UNITED STATES PATENT AND TRADEMARK OFFICE

APPLICATION NO.	FILING DATE	FIRST NAMED INVENTOR	ATTORNEY DOCKET NO.	CONFIRMATION NO.
10/613,513	07/03/2003	Brian Y. Lim	ATOMP001	4790
51111 7590 03/20/2009 AKA CHAN LLP 900 LAFAYETTE STREET SUITE 710 SANTA CLARA, CA 95050			EXAMINER ELVE, MARIA ALEXANDRA	
			ART UNIT 3742	PAPER NUMBER
			NOTIFICATION DATE 03/20/2009	DELIVERY MODE ELECTRONIC

Office Action Summary

DETAILED ACTION

Figure 1B Dai et al. (WO 02/081366A1) shows localized heating zones (8) with multiple heating prongs or laser beam prongs.

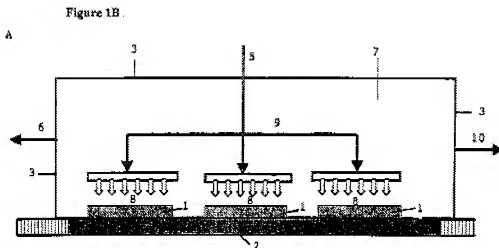
beam. Temperatures range from 300 to 800°C. Localized heating zones (8) have multiple prongs, as shown in figure 1B below:

It would have obvious to one of ordinary skill in the art at the time of the invention to modify Colbert et al. to use multiple prongs for heating as taught by Dai et al. because it ensures even heating and hence uniform nanotube formation.
